The Commission has issued the enclosed Amendment No. 8 to Facility Operating License No. NPF-16 for the St. Lucie Plant, Unit No. 2. The amendment consists of changes to the Technical Specifications in response to your application dated June 4, 1984.

The amendment revises the technical specifications for Cycle 2 operation of St. Lucie 2.

FLORIDA POWER & LIGHT COMPANY
ORLANDO UTILITIES COMMISSION OF
THE CITY OF ORLANDO, FLORIDA
AND
FLORIDA MUNICIPAL POWER AGENCY
DOCKET NO. 50-389
ST. LUCIE PLANT UNIT NO. 2
AMENDMENT TO FACILITY OPERATING LICENSE

By letter dated June 4, 1984, the Florida Power and Light Company (FP&L) submitted a request to reload and operate St. Lucie Plant Unit No. 2 for Cycle 2 (Ref. 1). In support of the request, the licensee submitted a reload safety analysis report (Ref. 2) and a statistical combination of uncertainties (SCU) methodology report (Ref. 3) applicable to St. Lucie 2.

FIGURE 3.2-2

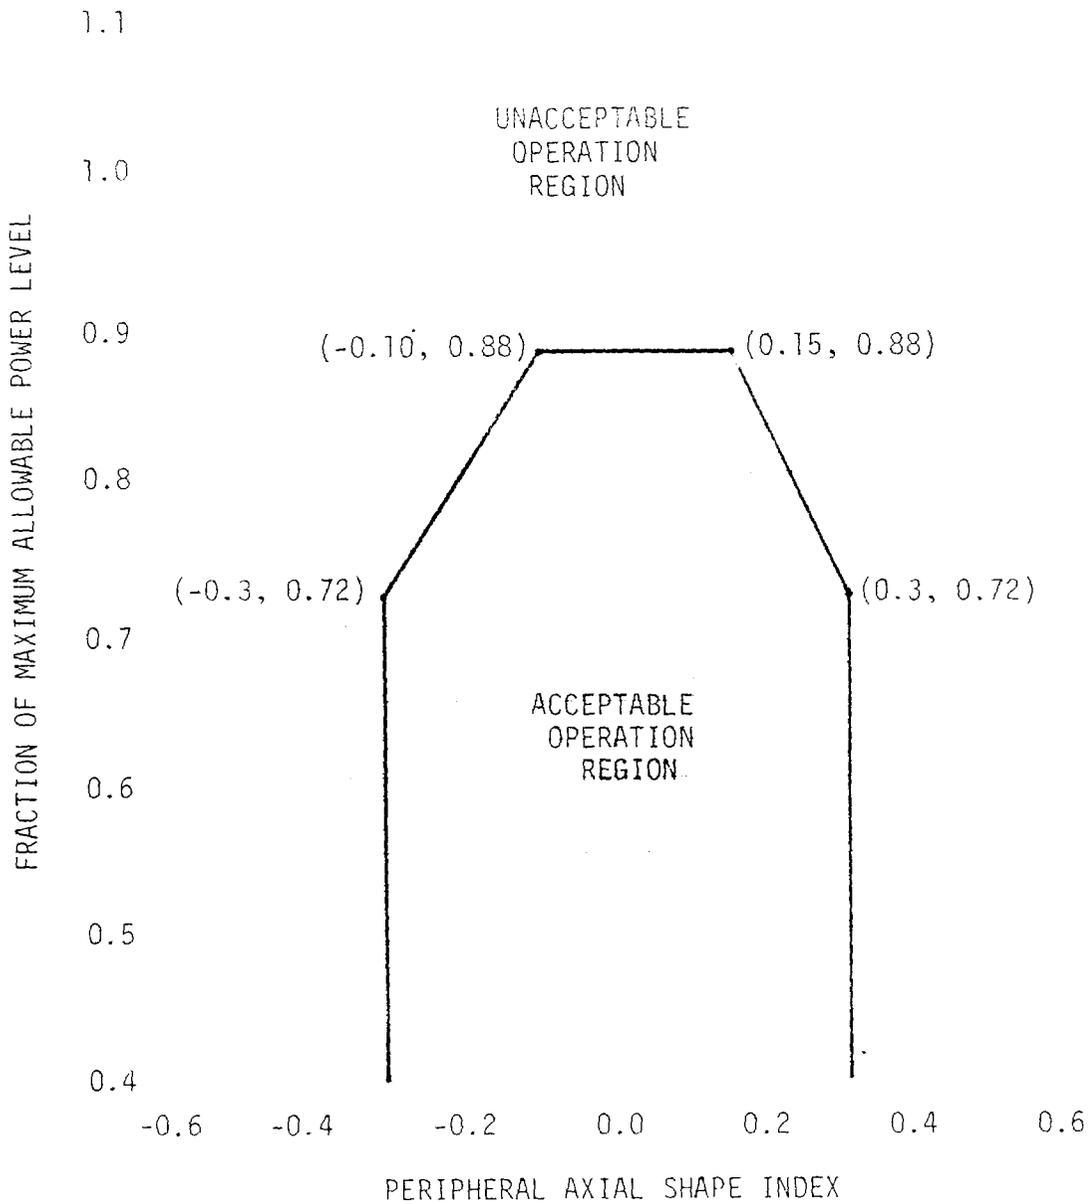
13. Figure 3.2-2 - The LHR excore LCO has been revised. This change reflects the approved reanalysis at 2700 MWt, the approved Technical Specification radial peaking factors and the implementation of approved margin recovery programs and is, therefore, acceptable.

FIGURE 3.2-3
ALLOWABLE COMBINATIONS OF THERMAL POWER AND F_r^T , F_{xy}^T

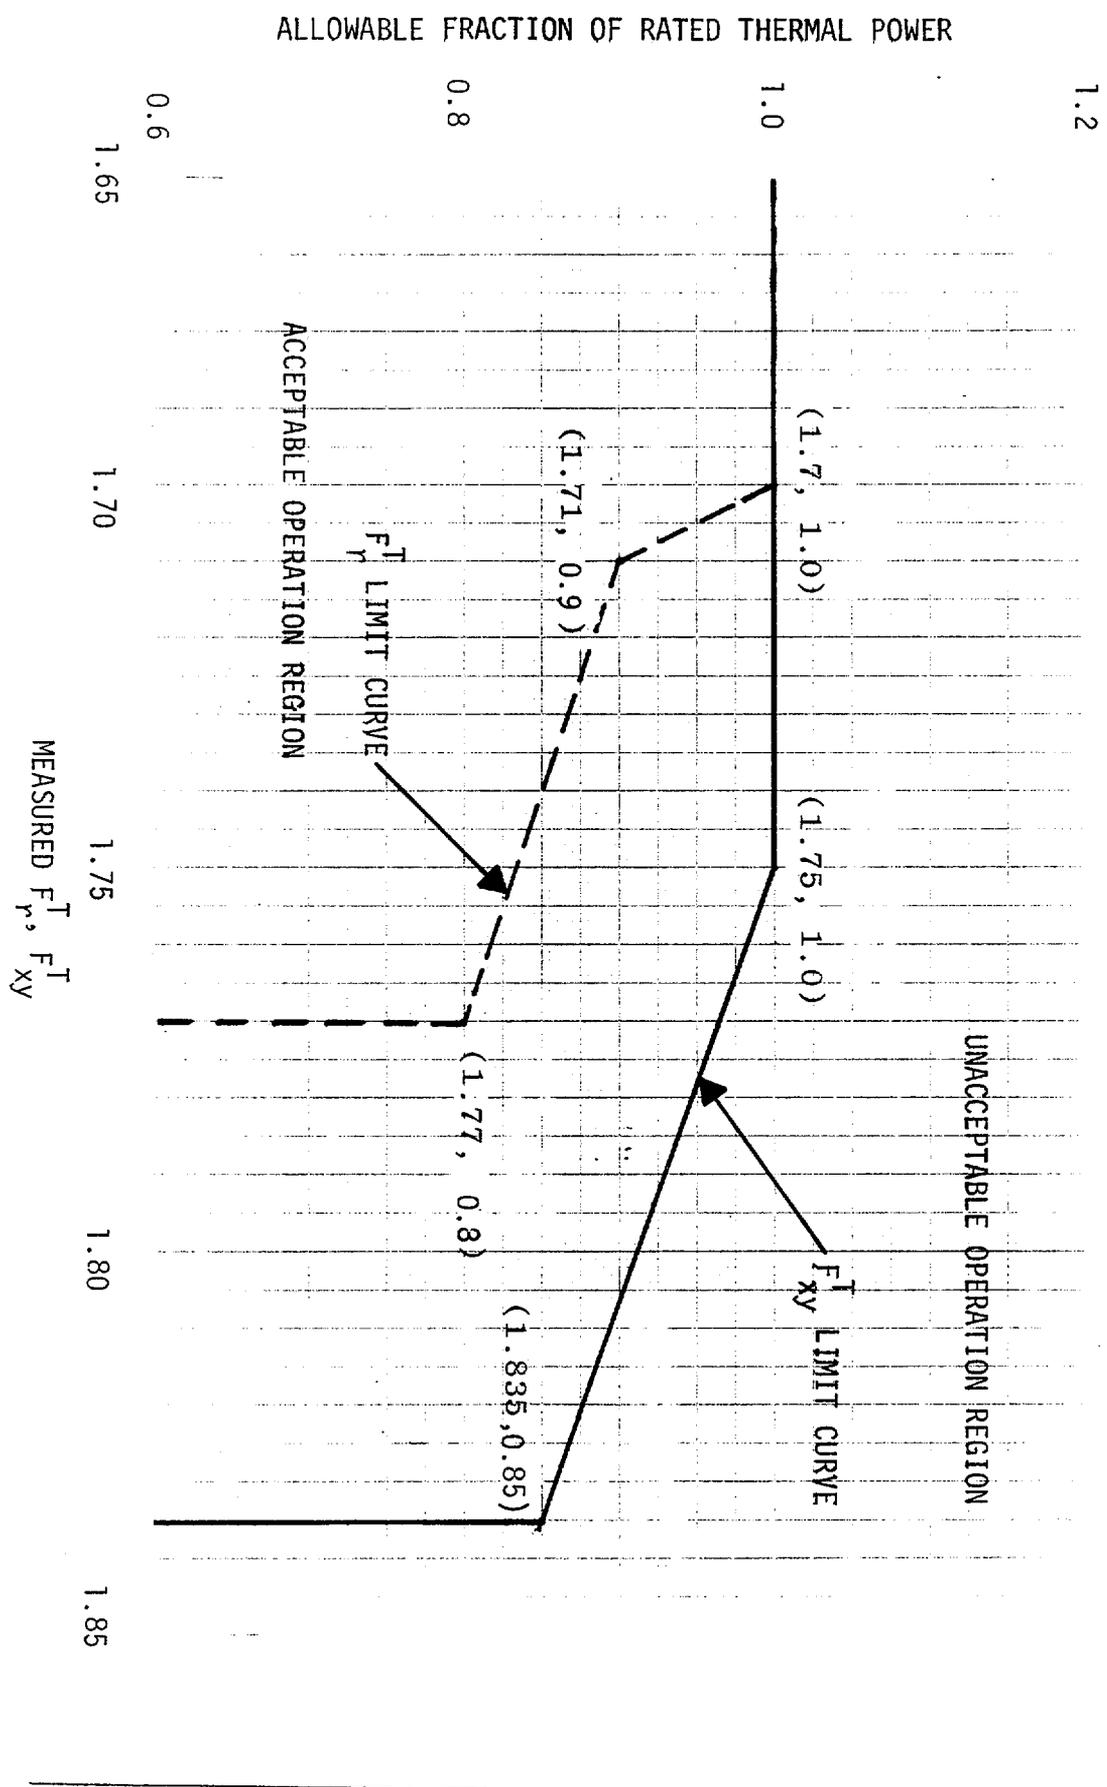
14. Figure 3.2-3 - The allowable combinations of thermal power and F_T , F_T^{xy} have been revised. This revision reflects the higher peaking factors and power level used in the approved safety analyses and is, therefore, acceptable.

FIGURE 3.2-4

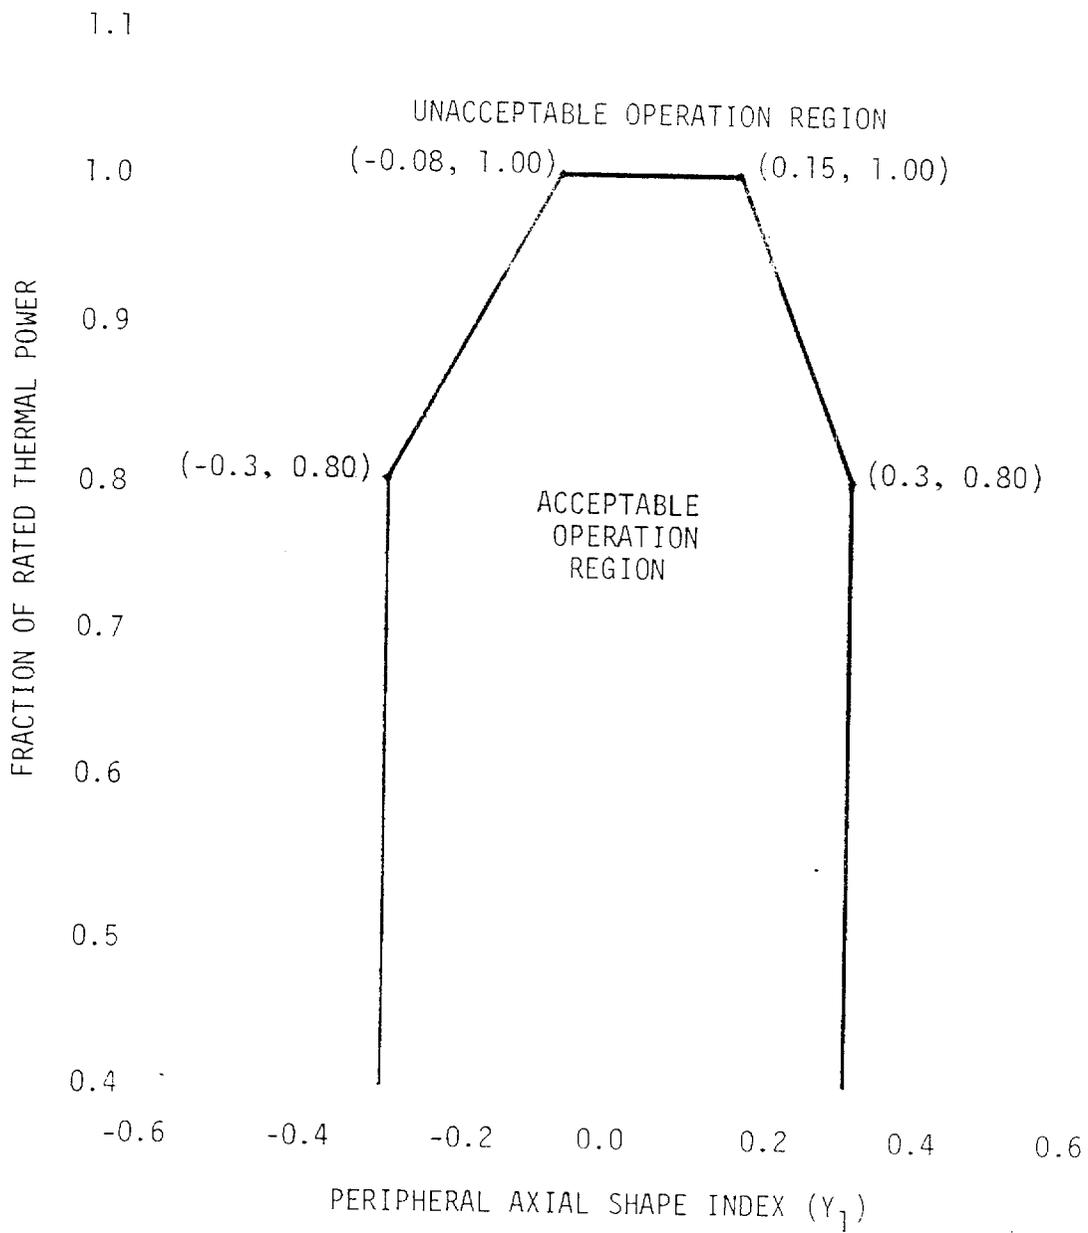
18. Figure 3.2-4 - The DNB LCO has been revised. This change reflects the approved reanalysis at 2700 MWt, the reactor coolant flow reduction to 363,000 gpm, the approved Technical Specification radial peaking factors, and the implementation of margin recovery programs and is, therefore, acceptable.
